REF: 21/03150/REM

Location: Begbroke Science Park Begbroke Hill Begbroke
OX5 1PF

19 October 2021

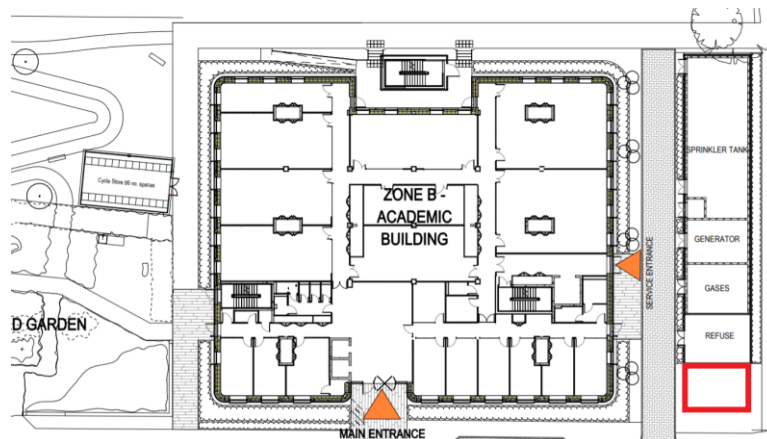
I have concerns that the cycle storage for the academic building is located in an area with little natural surveillance, also screened from view by a large established hedge. This leaves the store vulnerable to crime and antisocial behaviour. Cycle crime is one of the biggest demands on policing within Oxford, and in order to address my concerns I ask that the store is located to a more appropriate location where it will be covered by sufficient natural surveillance. Having reviewed the site, I believe the cycle store would be far better located to the south of the proposed ancillary building, next to the bin store which is much better suited location:

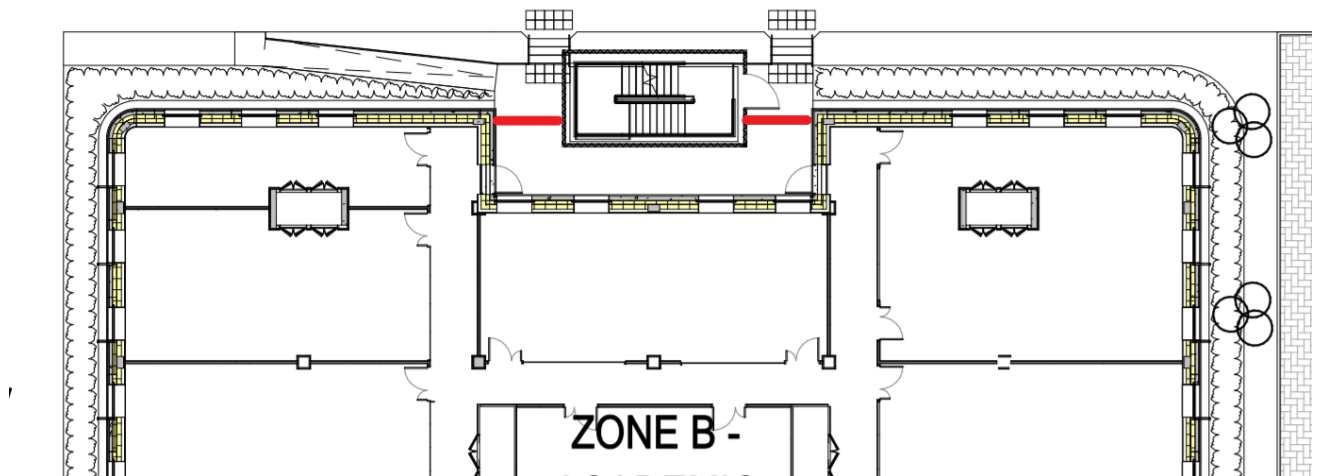
I have concerns that the fire escape staircase to the north of the building creates a large recessed and covered area, leaving ground floor fire escape doors very vulnerable as they are easily accessible with no surveillance. I ask that this area is enclosed to remove the recess and associated risk to the buildings security. No recessed areas should be present that are more than 600mm in depth:

All fire escape doors must also be robustly secured to a minimum LPS 1175 SR2, and should have no external door furniture.
